SUBJECT: Addendum No. 4

REFERENCE: Invitation To Bid (ITB) for HOU Restroom Renovation Phase 2; Solicitation No. HHG-HRESTR-2022-019; Project No. PN209A

NARRATIVE ADDENDUM NO. 4

C2 MENS 126 C
SCALE: 3/8" = 1'-0"

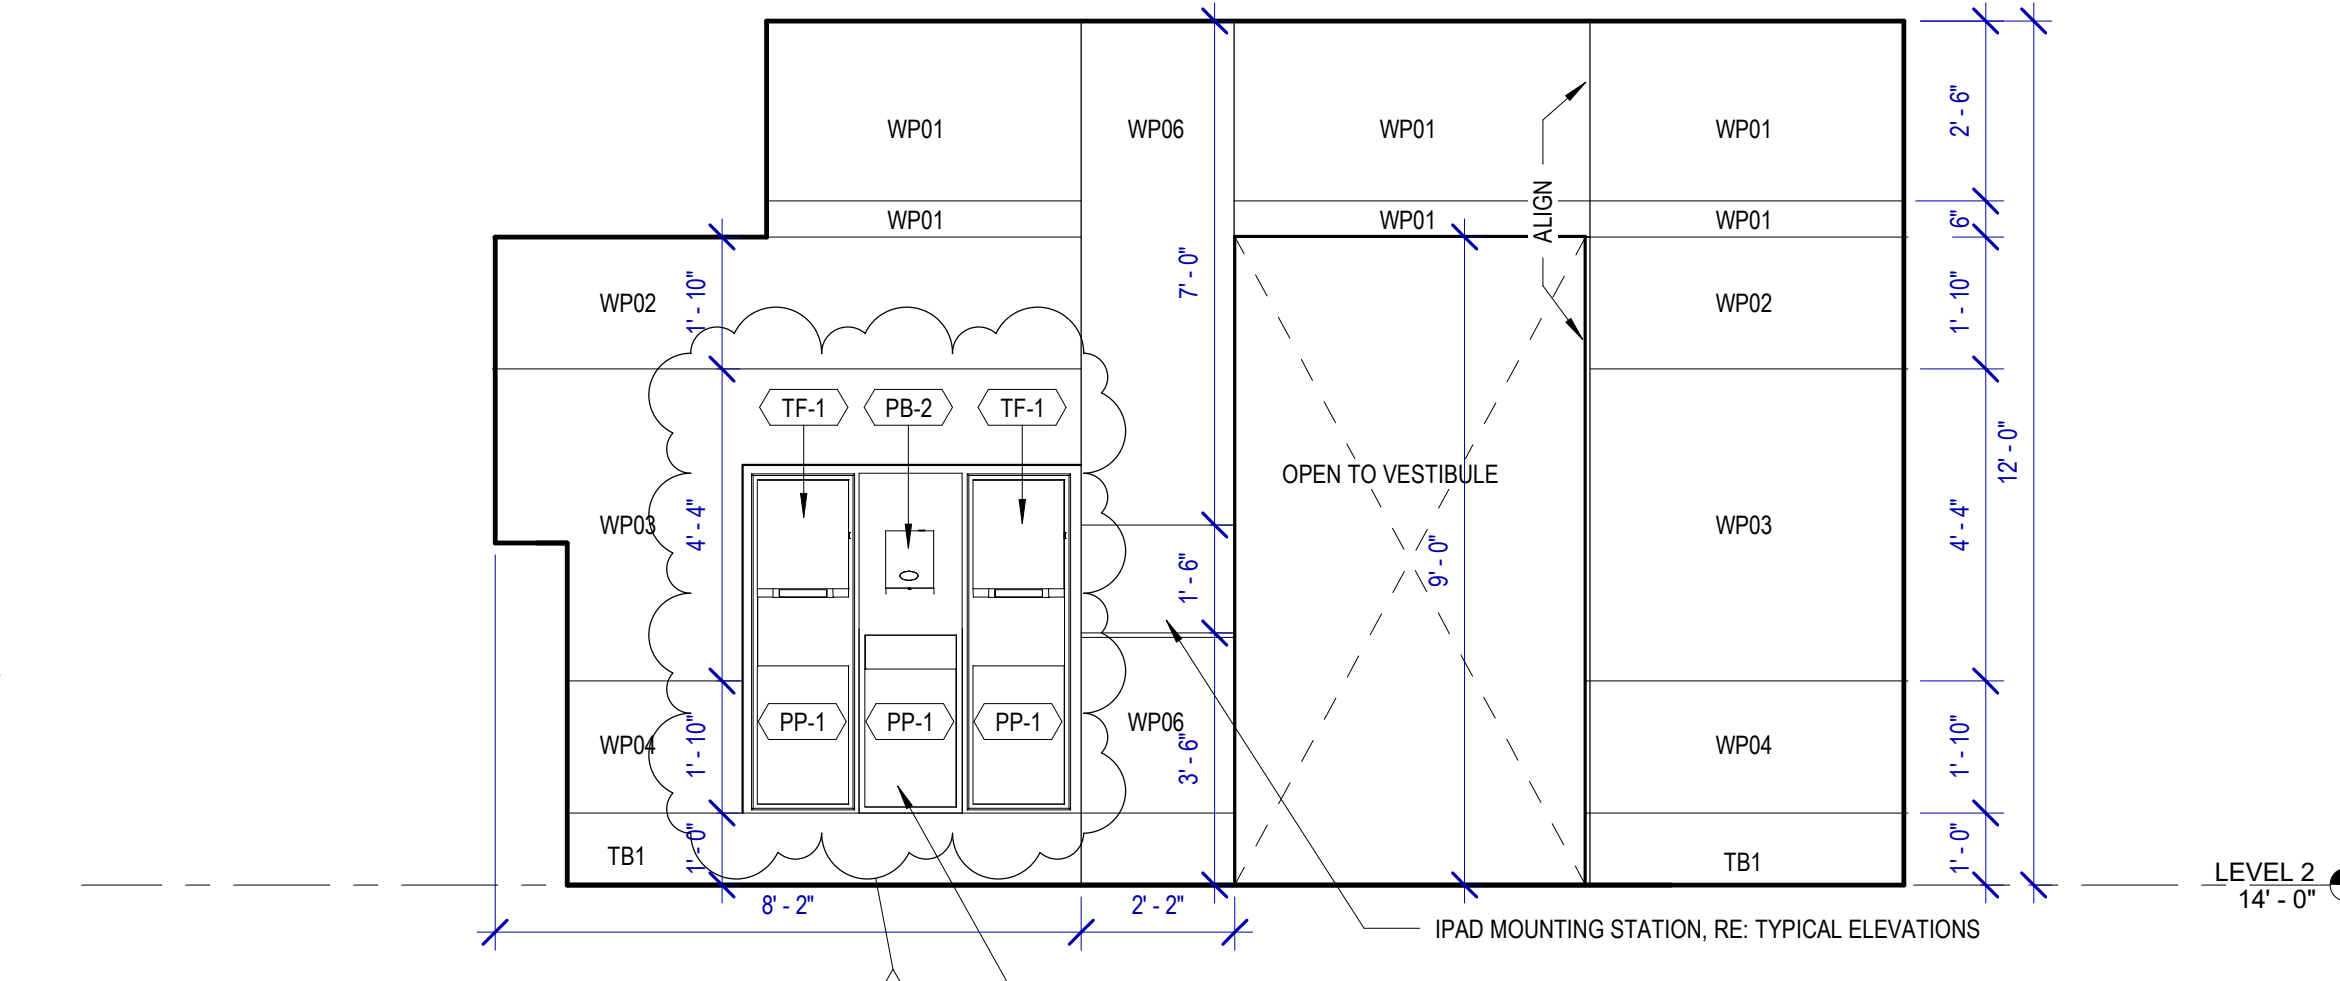
A-422	<ul style="list-style-type: none"> a. Toilet Accessories legend and Plumbing fixtures legend updated: <ul style="list-style-type: none"> 1. Not used items PC4, PC5 and PS1 were deleted. 2. Lovair accessories were renamed to read Splash Lab USA. ID information updated for PF-1, PF2, PO-1, PL-1, and PL-2. 3. PM-1 Carvart Frameless LED Mirror Added. 4. TF-1 model # revised to read: 461202. b. Detail B2 Revised. <ul style="list-style-type: none"> 1. Back Splash added 2. Mirror dimensions added. 3. Symbol PM-2 added. 4. Trespa panels symbols revised for clarification. c. Detail B1 and A3: Trespa panel symbol WP05 added for clarification
	A-423	<ul style="list-style-type: none"> a. Toilet Accessories legend and Plumbing fixtures legend updated: <ul style="list-style-type: none"> 1. Not used items PC4, PC5 and PS1 were deleted. 2. Lovair accessories were renamed to read Splash Lab USA. ID information updated for PF-1, PF2, PO-1, PL-1, and PL-2. 3. PM-1 Carvart Frameless LED Mirror Added. 4. TF-1 model # revised to read: 461202. b. Detail C2 Revised. <ul style="list-style-type: none"> 1. Back Splash added 2. Mirror dimensions added. 3. Mirror Symbol revised to read PM-2. c. Detail A3: Trespa panel symbol WP06 added for clarification d. Detail B1: Sanitizing Station revised to add symbol TF-1 e. Detail A1: TL3 Symbol added.

NOTE:
PROVIDE 16 ROOM SIGNS, REFER DOOR SCHEDULE FOR LOCATION.

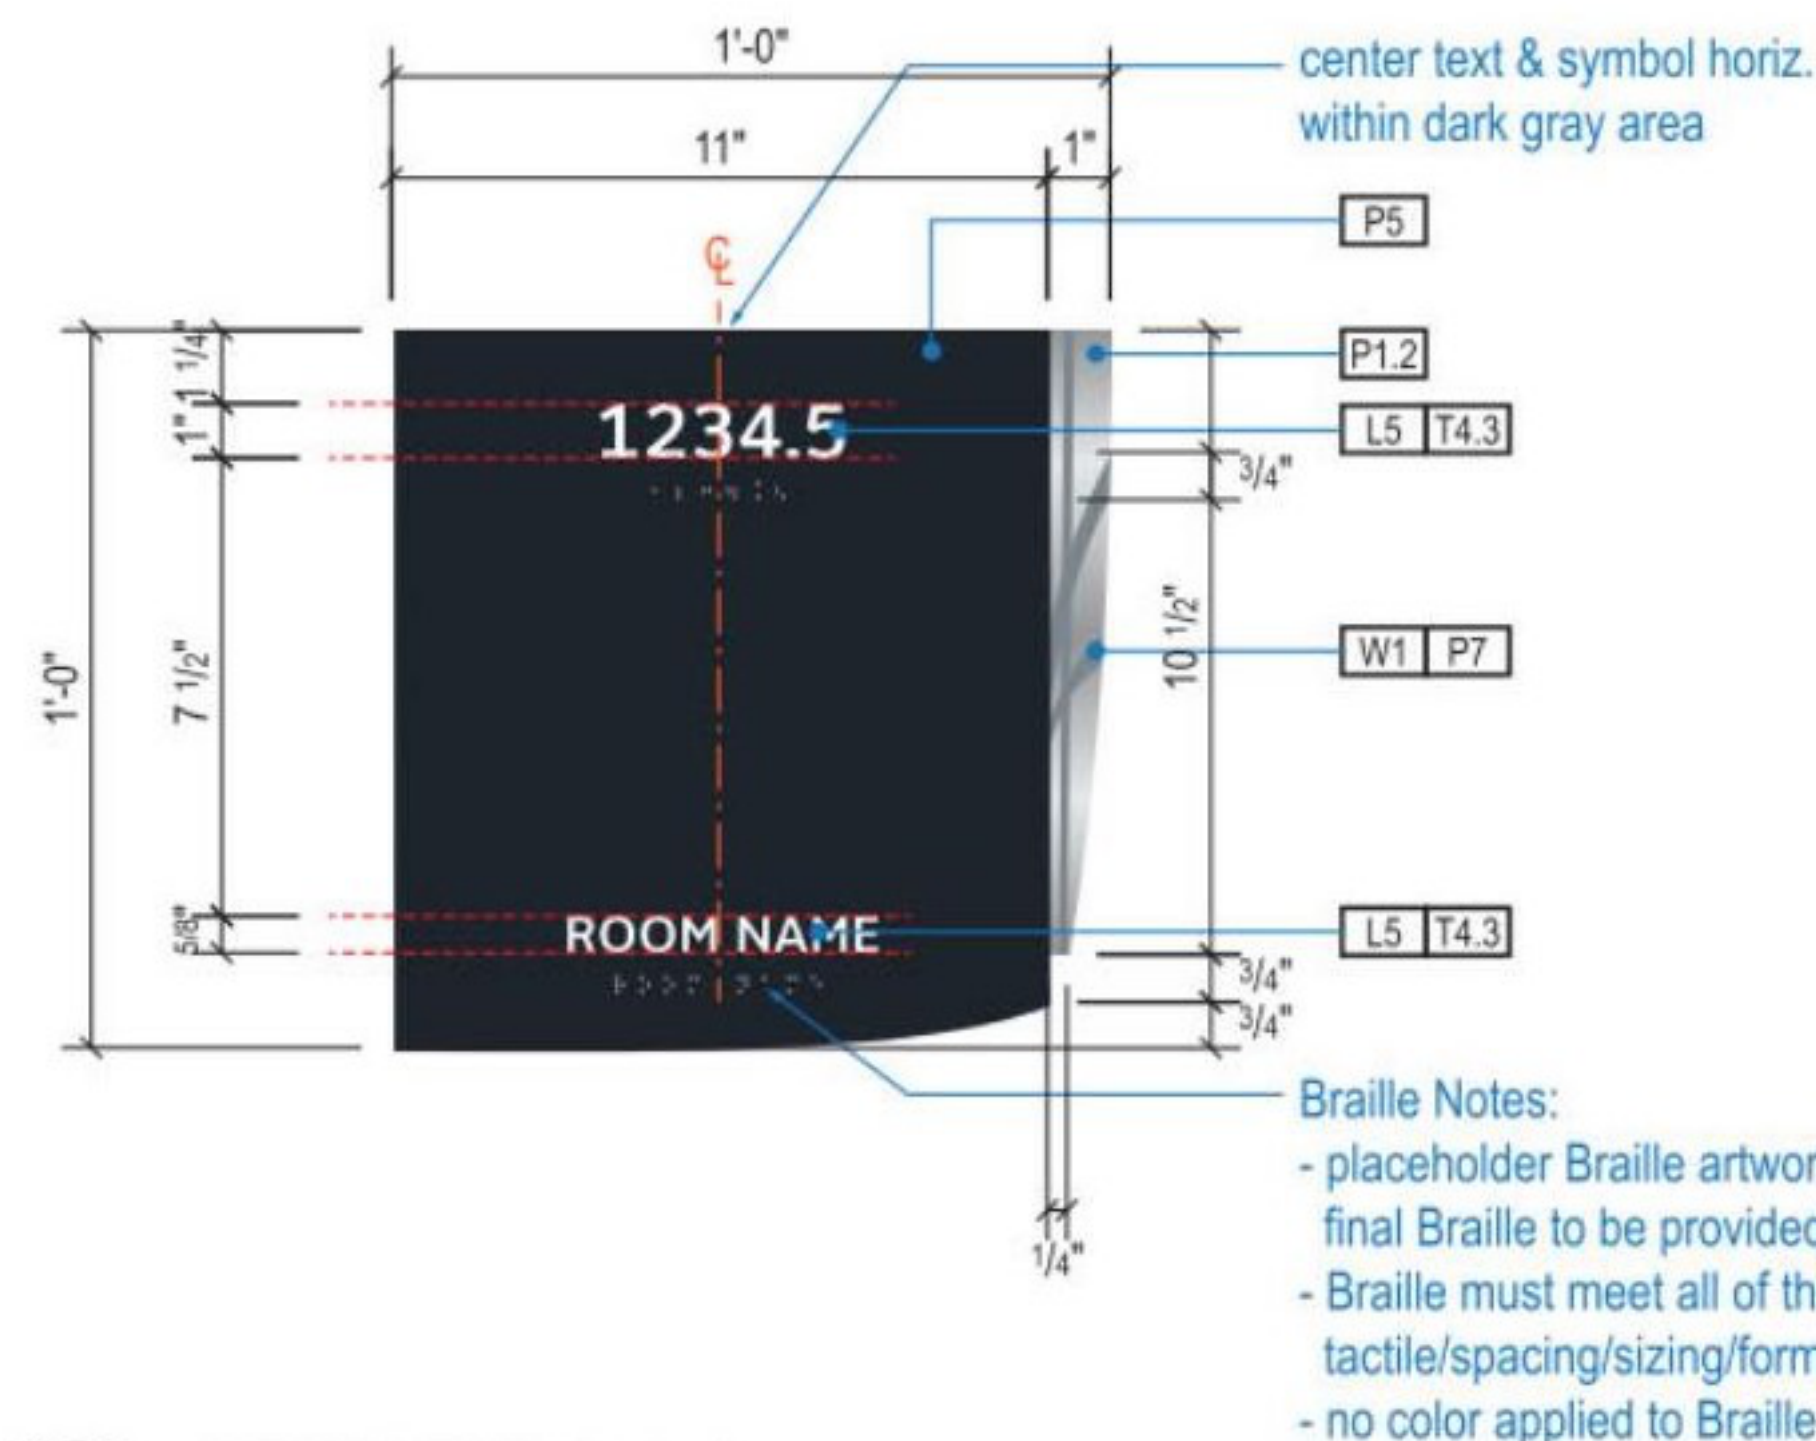
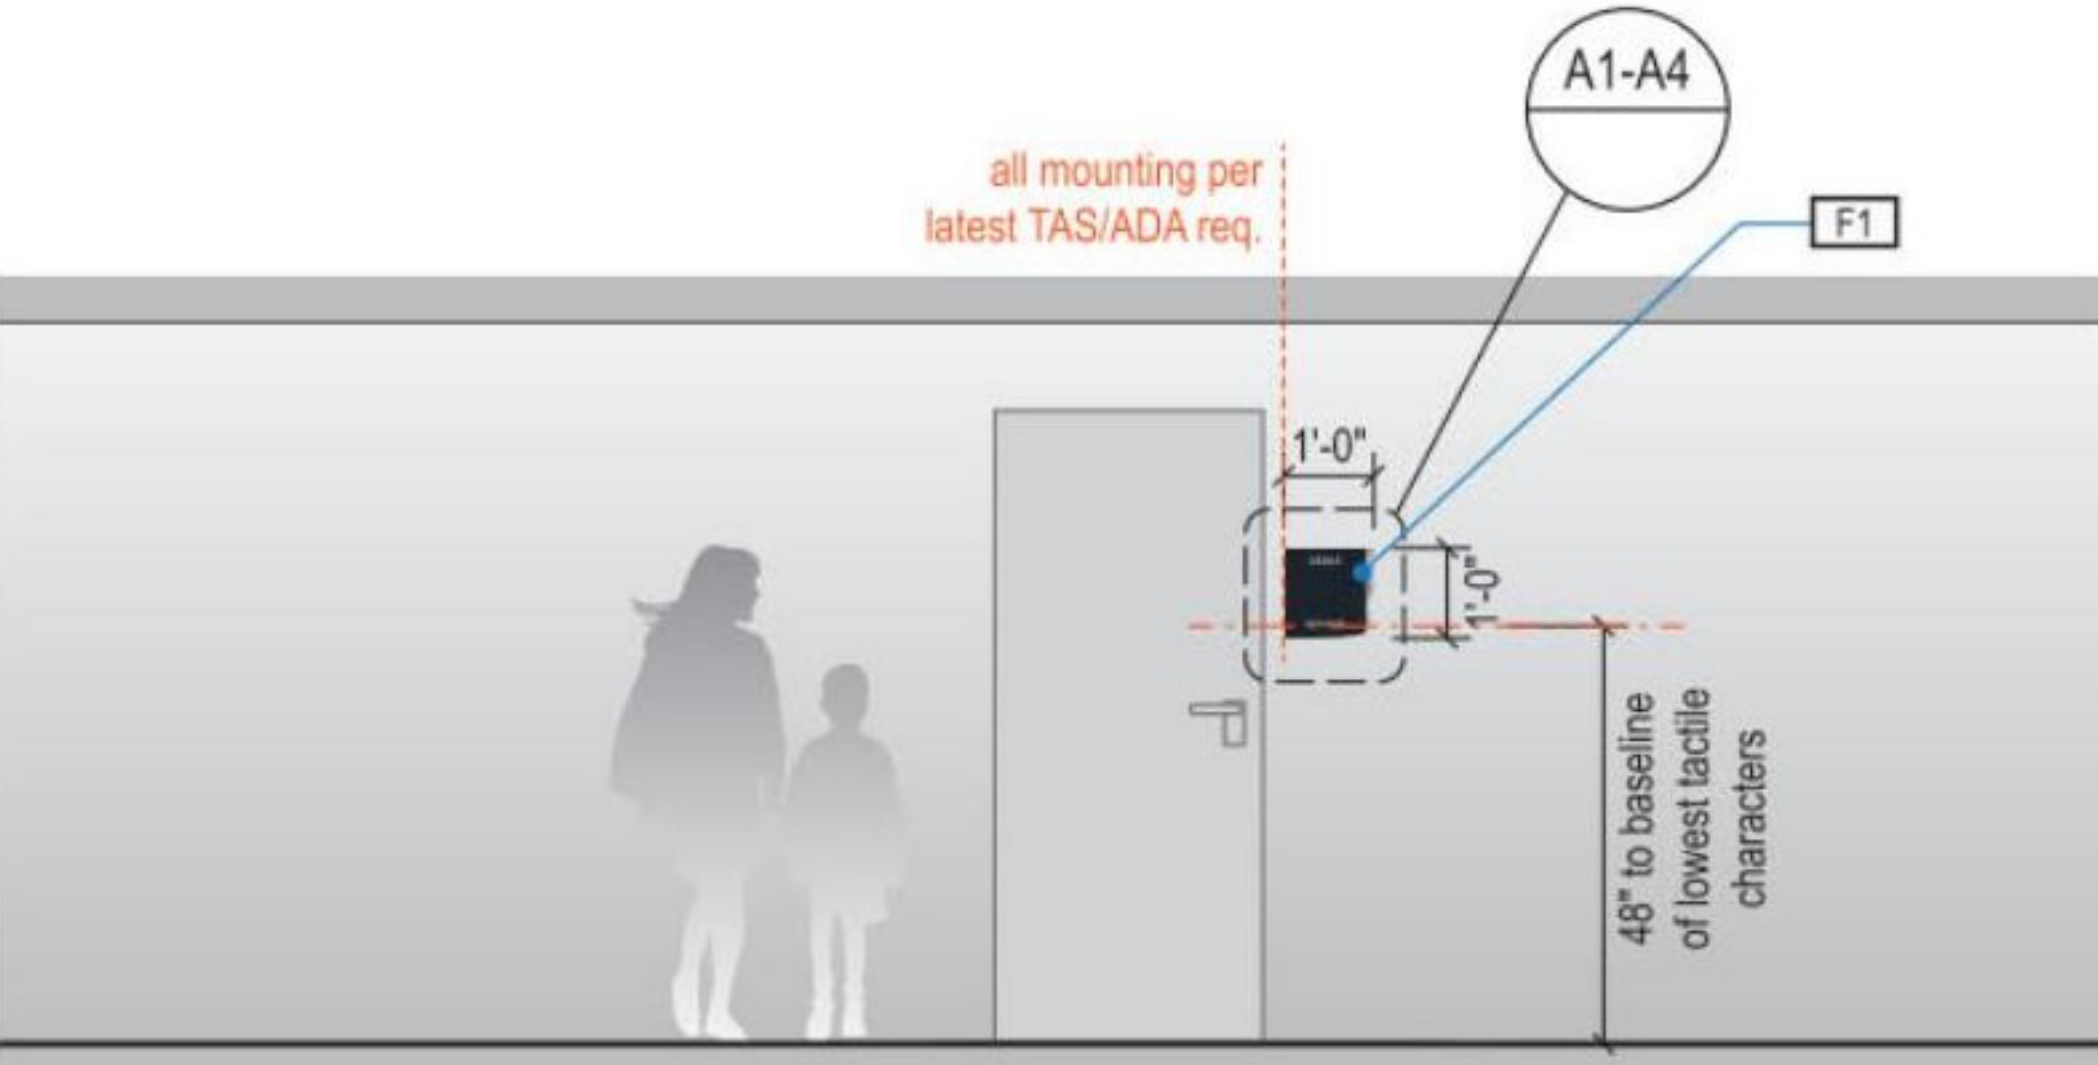
A-510	<ul style="list-style-type: none"> a. Detail A1 and Detail C1 Backing board were revised to read “$\frac{3}{4}$” CEMENT BOARD BACKING”. b. Detail B2 revised: <ul style="list-style-type: none"> 1. PM-1 LED Carvart Mirror added. 2. Mirror dimensions added. 3. Casework dimensions revised. 4. Note added to coordinate equipment/power cutouts as required. c. Detail C4 revised: <ul style="list-style-type: none"> 1. CS2 Back Splash added. 2. Lovair Ribbon Systems accessories were renamed to read Splash Lab USA.
	A-511	<ul style="list-style-type: none"> Detail A1 revised. <ul style="list-style-type: none"> 1. PM-1 LED Carvart Mirror Added. 2. Mirror dimensions revised. 3. LED noted revised
	A-600	<ul style="list-style-type: none"> a. WP05 Color revised to read: K32.2.1 Translucent Green Satin. b. Door Type revised to read Type ‘A’ required. Door type ‘B’ Deleted.
	A-604	Room Signage quantity revised: 16 room signs required.
